NRL Report No. B-1645

Report of Test

Horns, Types H-8 and H-9

Submitted by Clark Cooper Company,

Cracked diaphragm

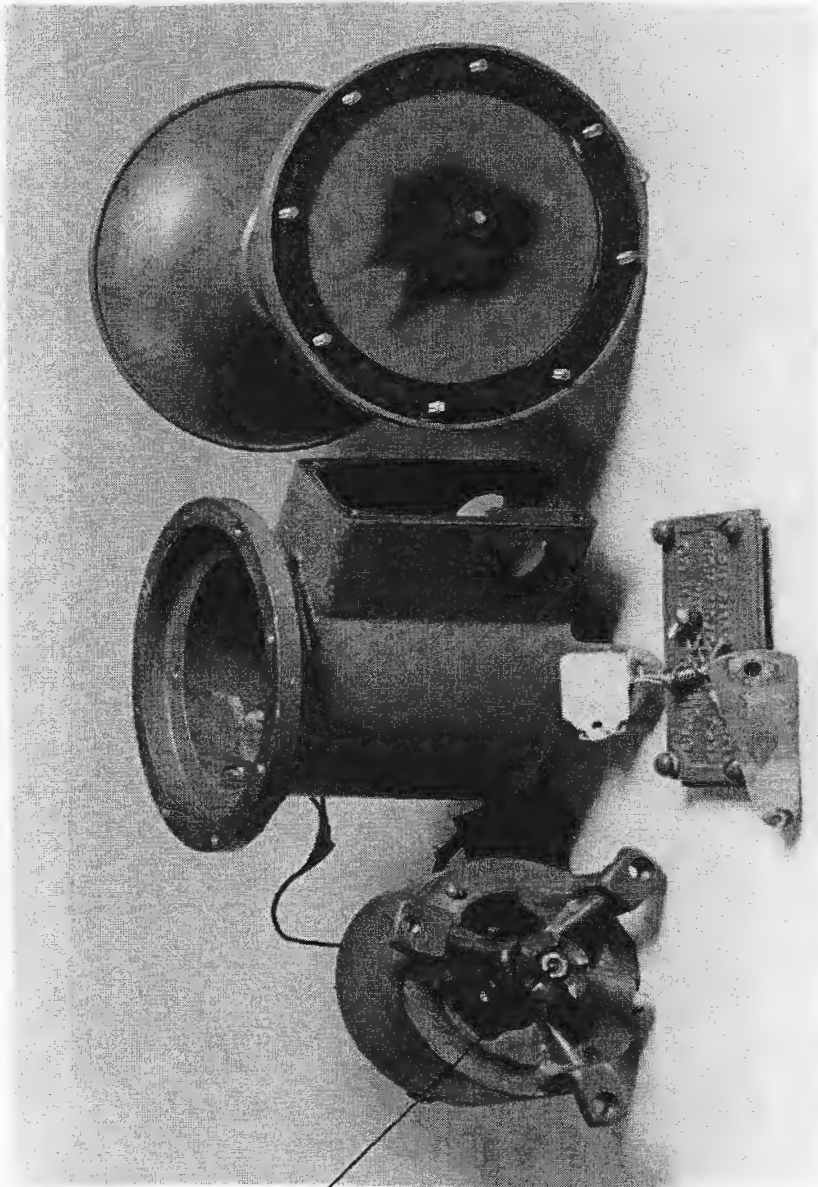
- (2) After 3 hours of operation, during the latter half of the endurance test at 0° C (28 hours total), the type H-8 horn failed. The diaphragm was found cracked and the end of the armature shaft, to which the ratchet wheel (pc. 4) is secured, was found broken.

Steel ball recessed
too deeply in armature shaft

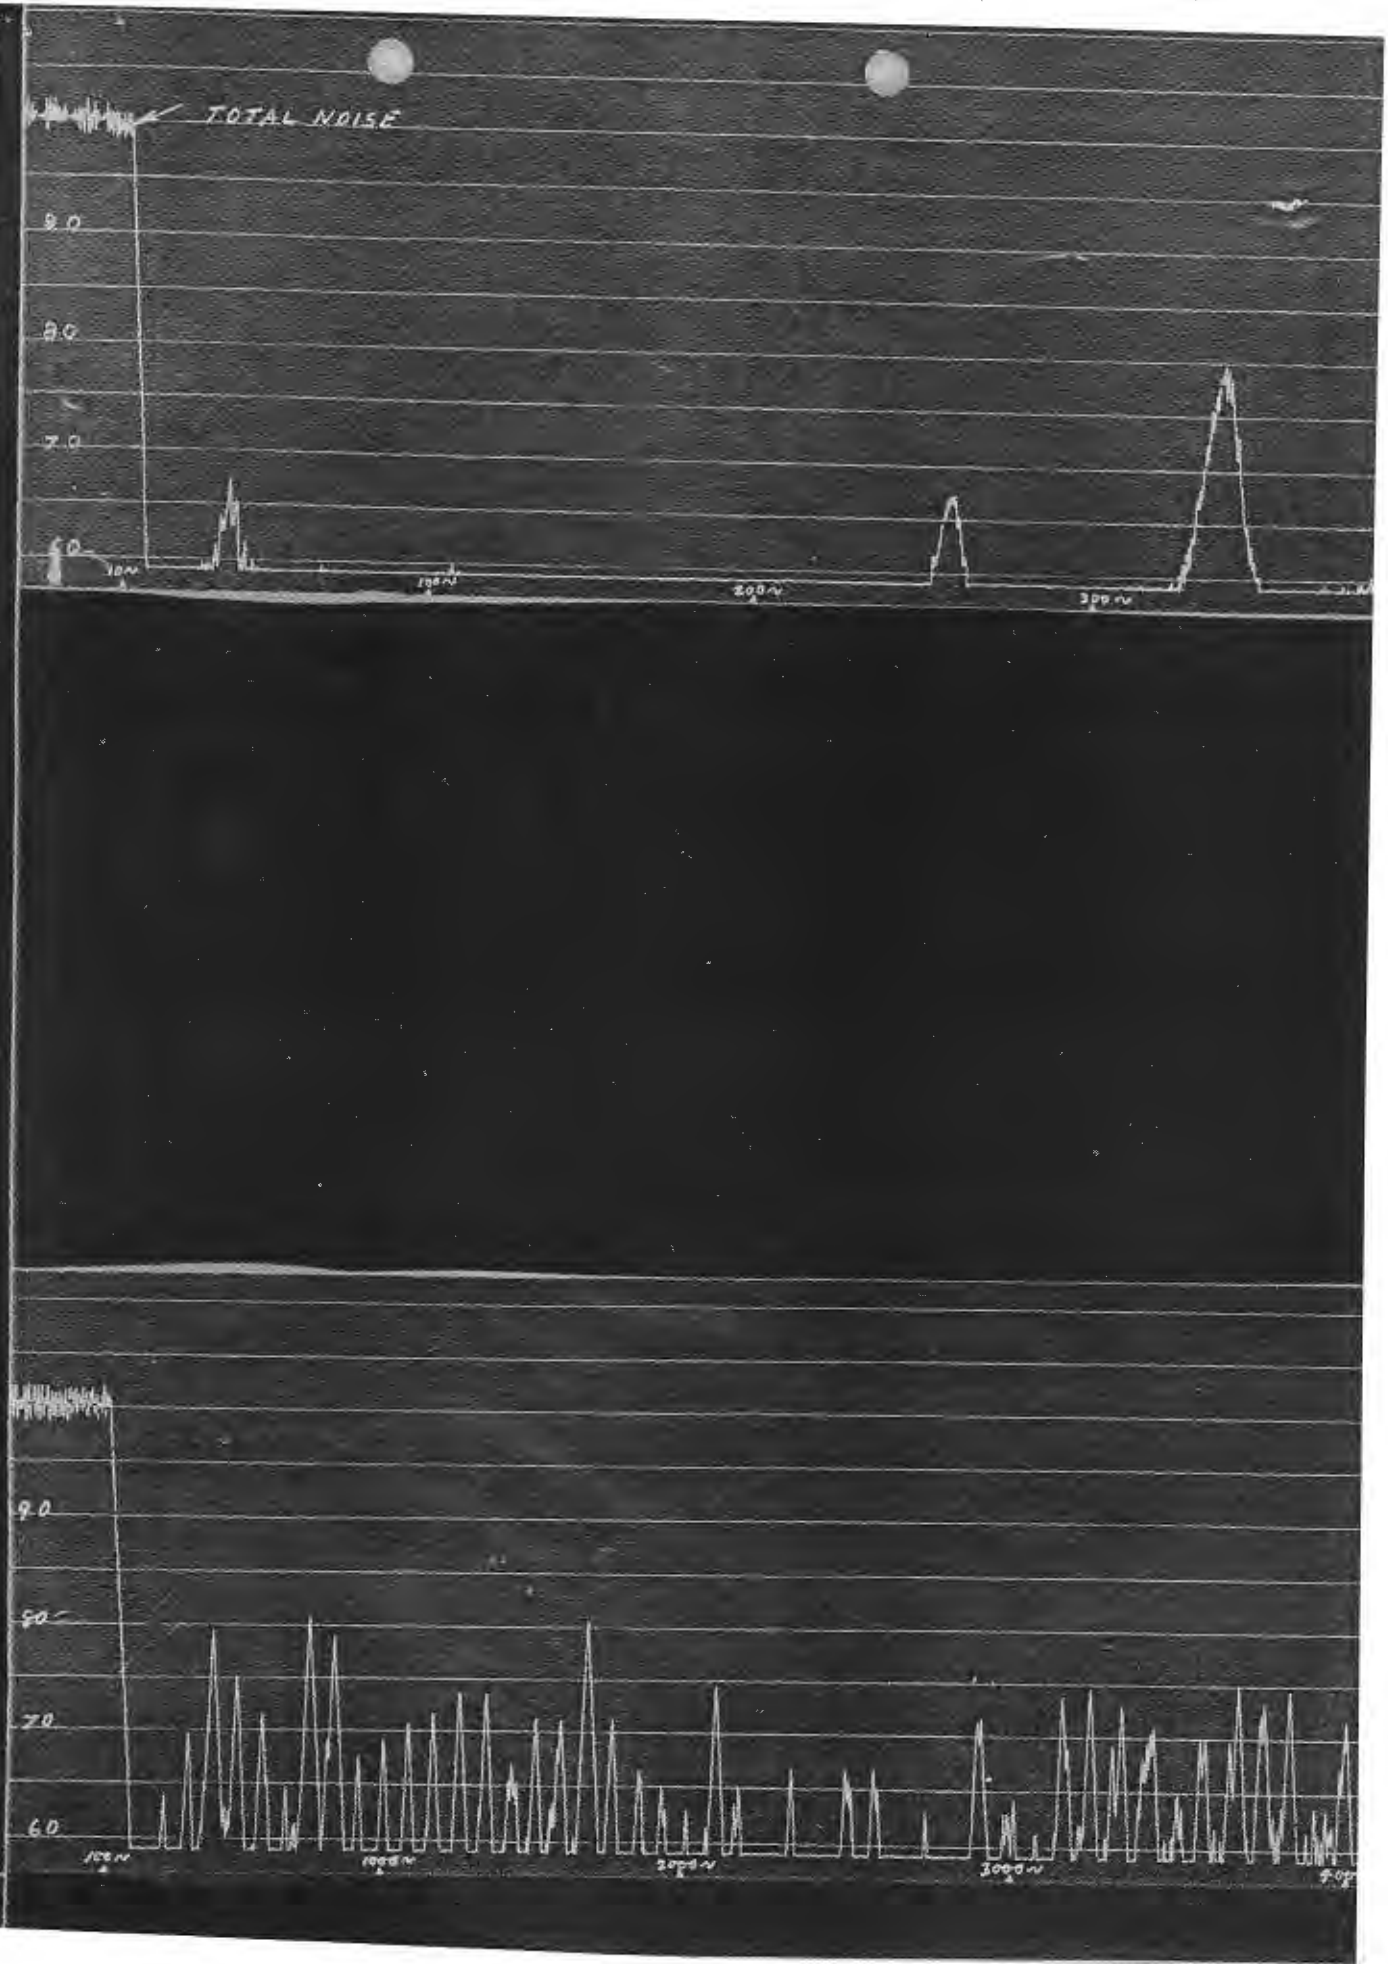
- (3) The type H-9 horn failed after 4 hours of operation at 0° C. (28 hours total). The motor's stalling was apparently due to the receding of the steel ball in the end of the armature shaft, allowing spring (pc. 8) to press against the ratchet wheel (pc. 4) and produce considerable friction.

- (5) Raised lettering is used on the connection box cover in lieu of the nickel-copper alloy nameplate, shown on drawing, reference (c).
- (b) It is considered that the adjusting screw and locknut (pcs. 18 and 19) should be of steel.
